# SERVICE BULLETIN

M-1403

## 2015 STREET LICENSE PLATE REFLECTOR REGULATORY NON-COMPLIANCE RECALL CODE 0620

**Figure 1. Reflector**

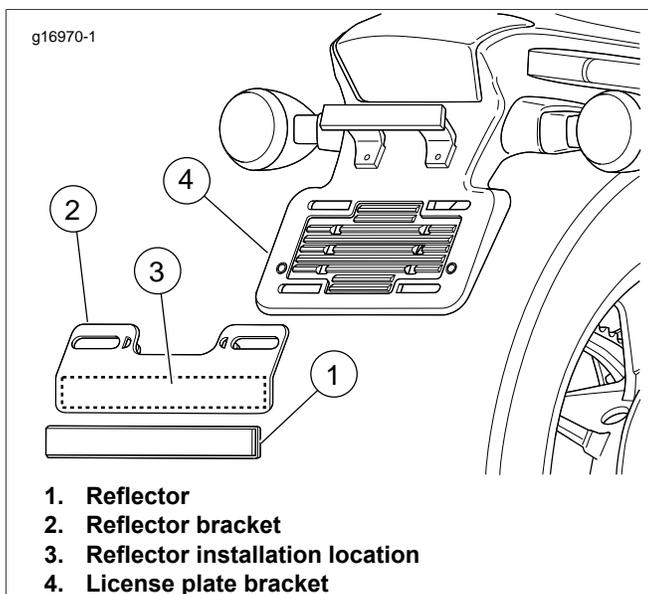
Certain model year 2015 Street family motorcycles built before 3/10/2015 in the Kansas City plant for the North America market (Domestic, California, Mexico and Canada configurations) may have been built without a rear reflector (Part No. 59988-72A). Without this reflector installed, the vehicle does not meet the lighting requirements of FMVSS 108 (U.S.) and CMVSS 108 (CAN). If this reflector is not installed it could reduce the rear conspicuity of the vehicle, possibly increasing the risk of a crash under certain conditions.

1. Verify that the motorcycle is involved in this recall.
2. Remove license plate (if necessary).
3. See Figure 1. Remove adhesive backing from reflector (1). Carefully center and align the reflector with the reflector installation location (3) on reflector bracket (2). Press reflector firmly into place.
4. Install reflector bracket to license plate bracket (4).
5. Install license plate (if necessary).
